RE: TRC Comments Response RG Towers - Ft Pierce- Orange Ave

**RE: TRC Comments Response RG Towers - Ft Pierce- Orange Ave
Project: # 17-04000033**

WSP PROJECT # 17-1404 RG TOWERS - ORANGE AVENUE

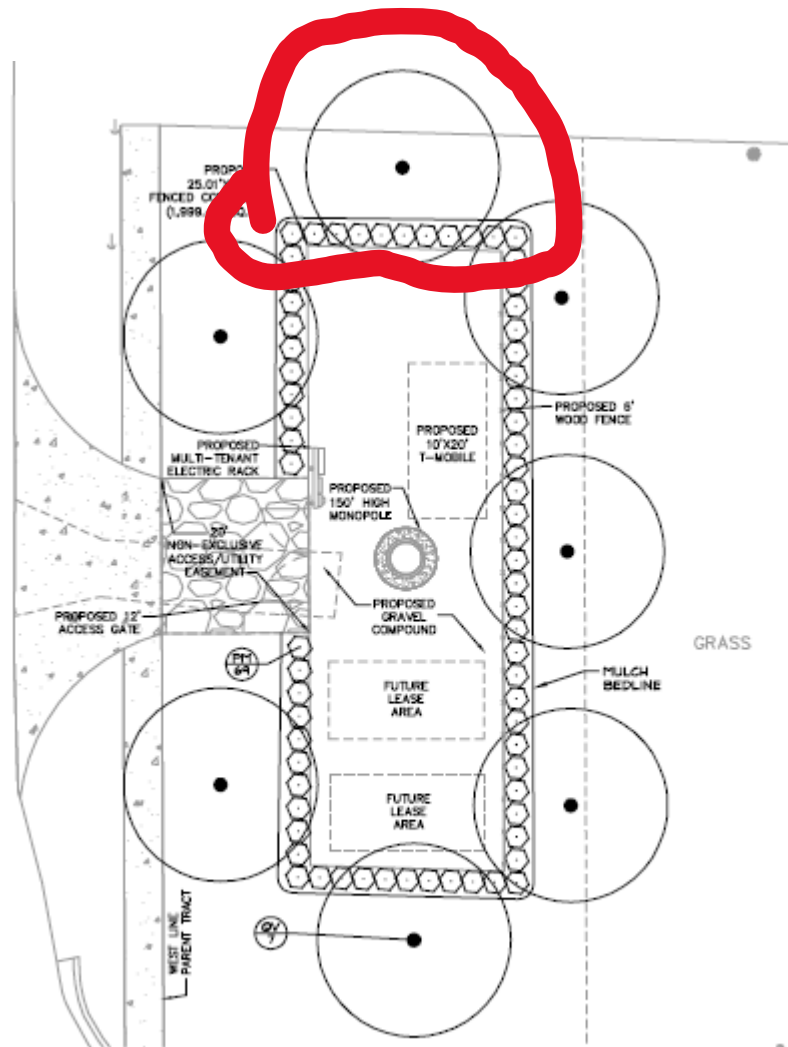
1. Look into the possibility of buffering the north property line from the adjacent ally way and residential home. This can be done by installing a 6 foot landscape buffer or a 6ft wood fence.

On Page 2/5 a 6' wooden fence is depicted to enclose the entire compound which includes the north side between the compound and the residential parcel to the north.

And on Page 4/5 a landscape buffer is already shown on the north side which consists of (11) 6 foot high podocarpus plants and (1) 10 foot live southern Oak with a five foot spread
